LEXINGTON-FAYETTE URBAN COUNTY GOVERNMENT CONTRACT CHANGE ORDER Page 1 of 2		Date:	July 6, 2016
To (Contractor): Marrillia Design & Construction 259 West Short Street Suite 325 Lexington, KY 40507		Project:	Senior Citizen Center Construction
		Location:	Lexington
		Contract No.	227-2014
		Original Contract Amt.	\$8,882,900.00
		Cumulative Amount of Previous Change Orders	\$1,527,223.37
		Percent Change - Previous Change Orders	17.19%
		Total Contract Amount Prior to this Change Order	\$10,410,123.37
		Change Order No.	51
You are hereby requested to comply with the following changes from the contract plans and specification;			
<b>Current Change Order</b>

PROJECT: Senior Citizen Center Construction

CHANGE ORDER NO. 51

PROJECT	LFUCG Senior Citizens' Center 201333	DATE SENT	3/31/2016
SUBJECT	Grout Cleaned Finish at Site Wall & Canopy Columns	PROPOSAL REQUEST ID	PR-064
TYPE	Proposal Request	TRANSMITTAL ID	00932
PURPOSE	For Review and Response	VIA	Info Exchange

1 CA - PARTIAL SOUTH ELEVATION  
 SKA-124 SCALE: 1/8" = 1'-0"

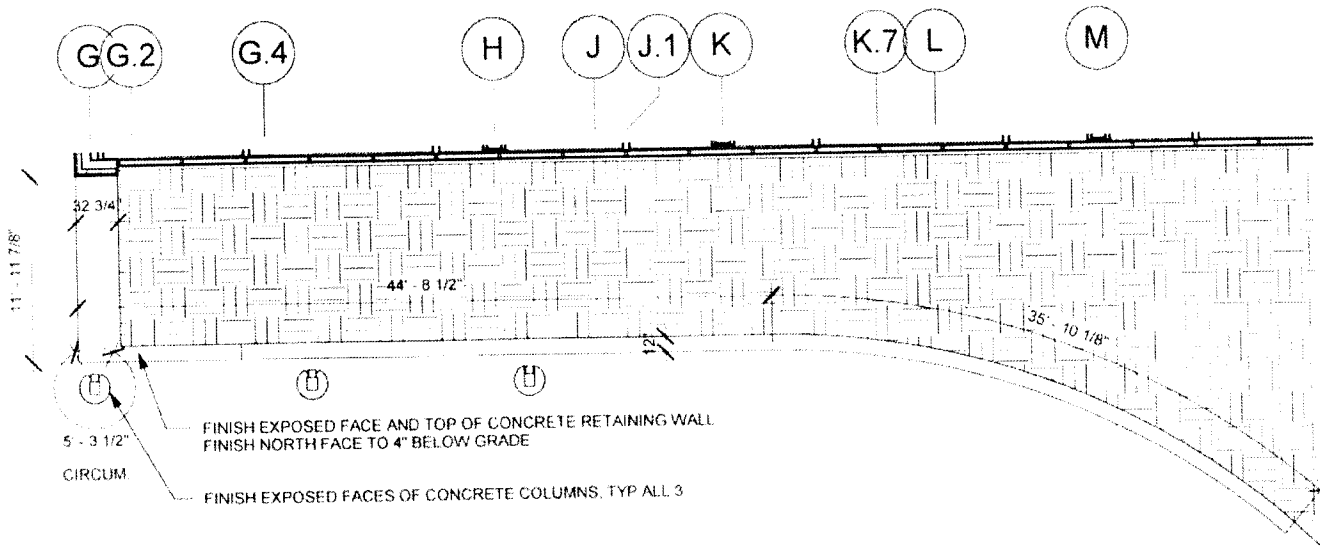
Please provide pricing to apply a grout-cleaned finish to the exposed faces of the south site elements, including the canopy columns and retaining wall. Refer to the attached sketch for the extents of finishing. Grout-cleaned finish shall be applied in accordance with ACI 301-96 specifications for rubbed finishes applied to smooth form finished concrete. Contractor shall submit data on the mix of grout for finishing, or other comparable materials for producing an equivalent finish.

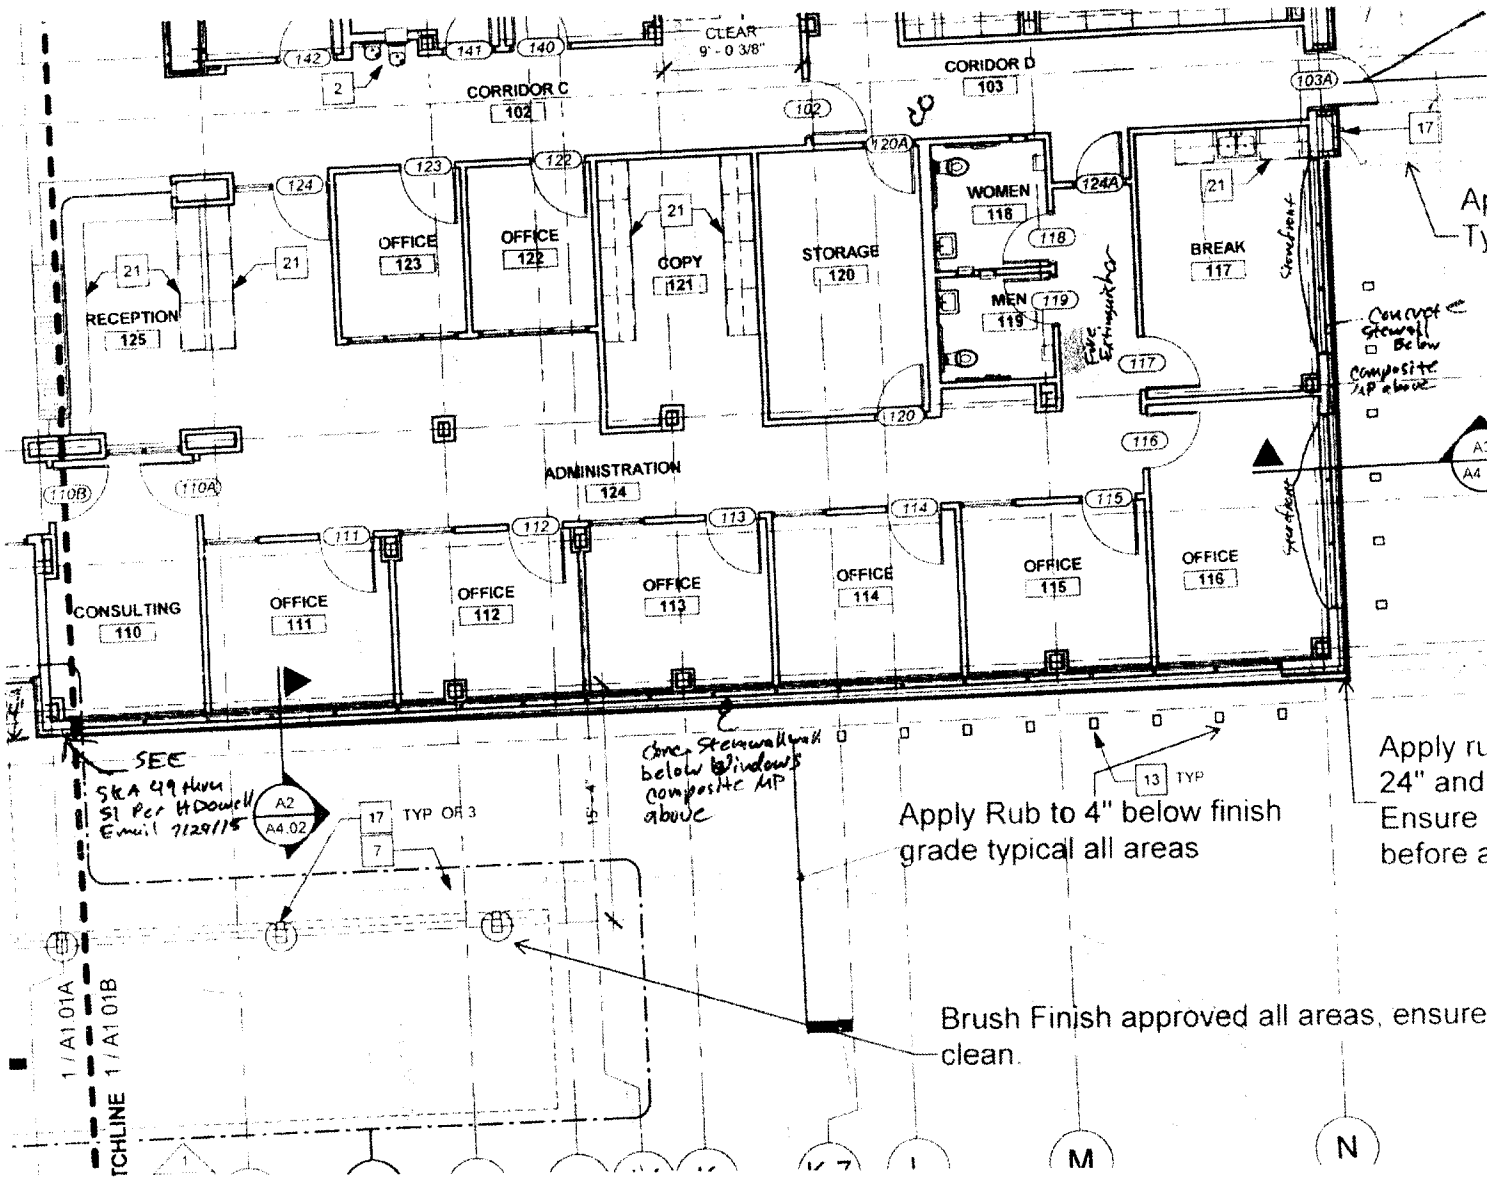
Additional Pricing as Requested by EOP, see  
attached Sketch.

- A. Provide seal coat 1000 finish on front wall around sun screen columns & exposed wall @ planter area

Apply rub to 4" below finish grade  
Typ.

Apply Rub from window sill down approx  
24" and lap installed waterproofing  
Ensure you pressure wash substrate  
before application at all areas Typical

Apply Rub to 4" below finish  
grade typical all areas

Brush Finish approved all areas, ensure lines are straight and  
clean.

1 CA-AV EQUIPMENT CABINET - SECTION  
 SKA-138 SCALE: 3/4" = 1'-0"

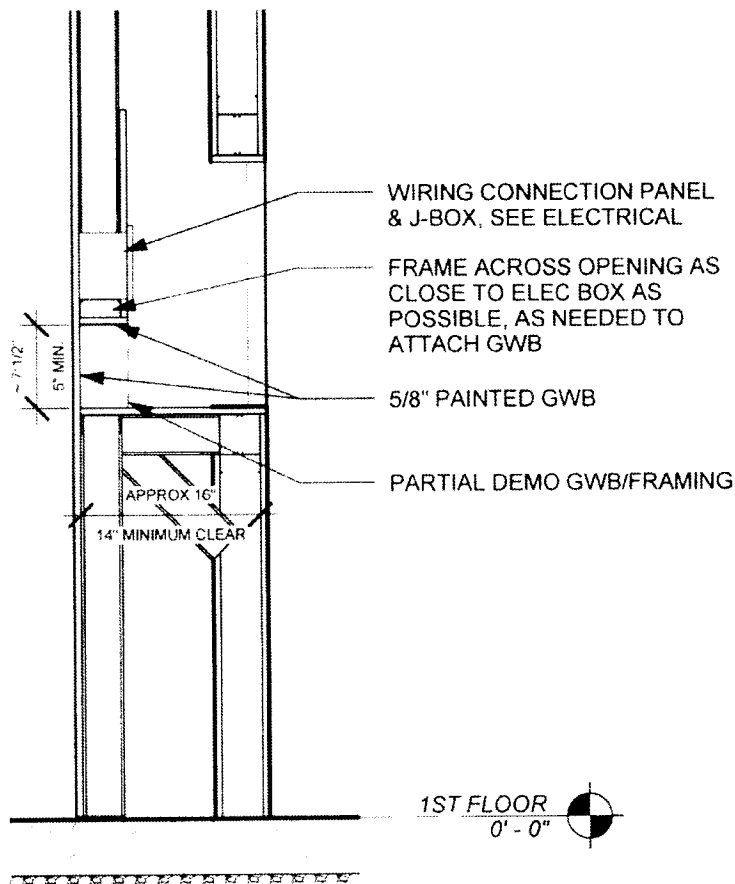
Please provide pricing to adjust the AV cabinet set in the north wall of Classroom 180. Refer to the enclosed sketch. Framing shall be adjusted to provide the largest practical area for the AV equipment without moving the electrical boxes from their current location.
